Consolidation Resolution on Road Signs and Signals

Proposed amendments to the Consolidated Resolution on Road Signs and Signals

Signs for Charging Points for Electrical Vehicles

Submitted by the Norwegian and Swedish Governments*

Fig *a* in annex VI

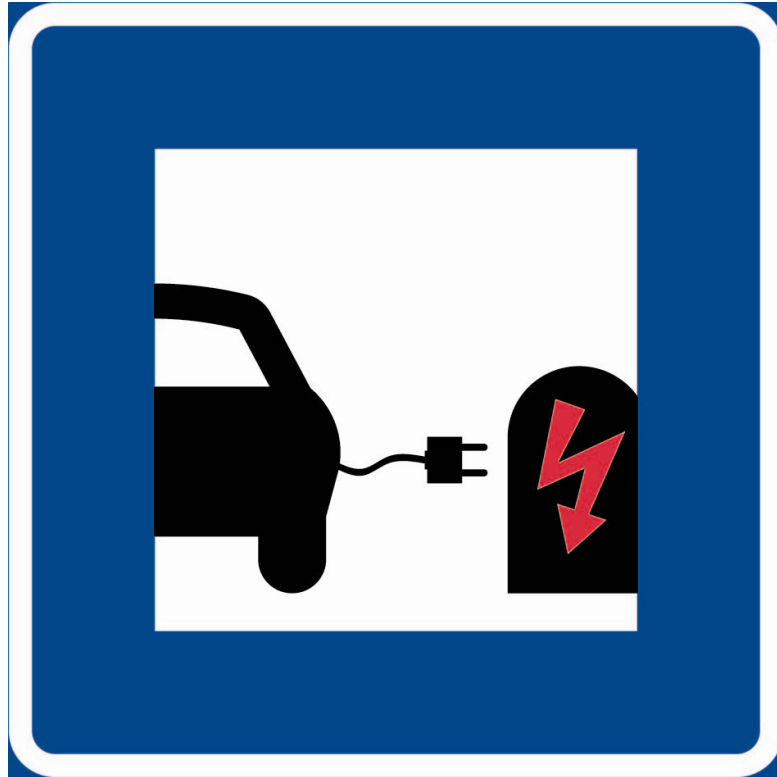
A new paragraph 1.13' is added:

1.13' Road sign to indicate charging points for electrical vehicles

In order to facilitate for consumers, it is recommended that the sign shown in figure *a* in annex VI of this Resolution should be used.

The sign is composed of the "F" sign as defined in the 1968 Vienna Convention on Road Signs and Signals, with the pictogram inscribed in black. The electrical symbol (arrow) may also be in white or yellow.

Fig 1b in annex V

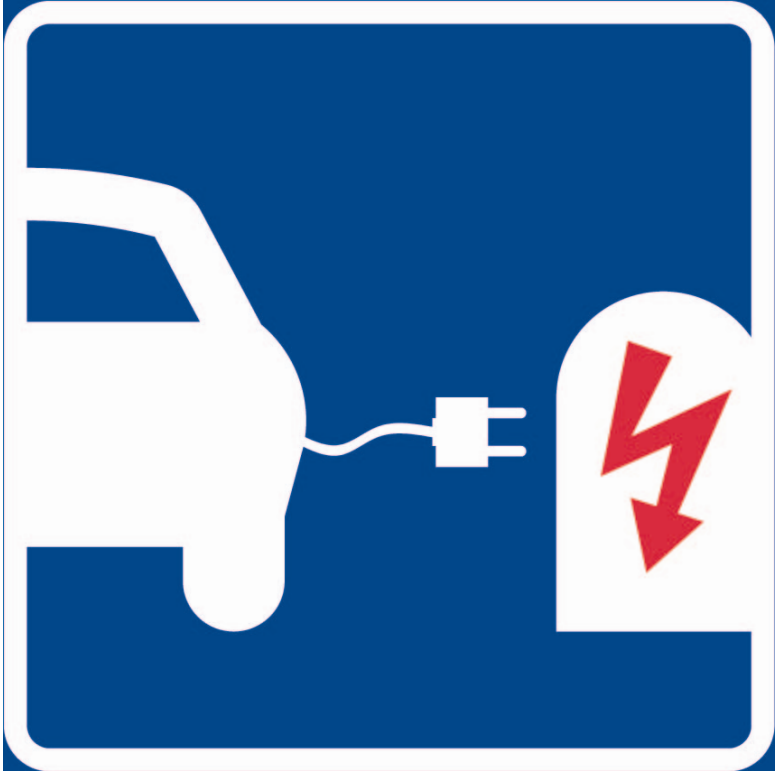
Point 1.12 letter b) is amended as follows:

The "electrical vehicle" panel shown in figure 1b of annex V to this Consolidated Resolution when used together with the sign E 14 a "Parking", as defined in the 1968 Vienna Convention on Road Signs and Signals indicates that parking is reserved for electric vehicles. The panel is composed of the "H" sign as defined in the 1968 Vienna Convention on Road Signs and Signals, with the pictogram inscribed. The electrical symbol (arrow) may also be in white or yellow.
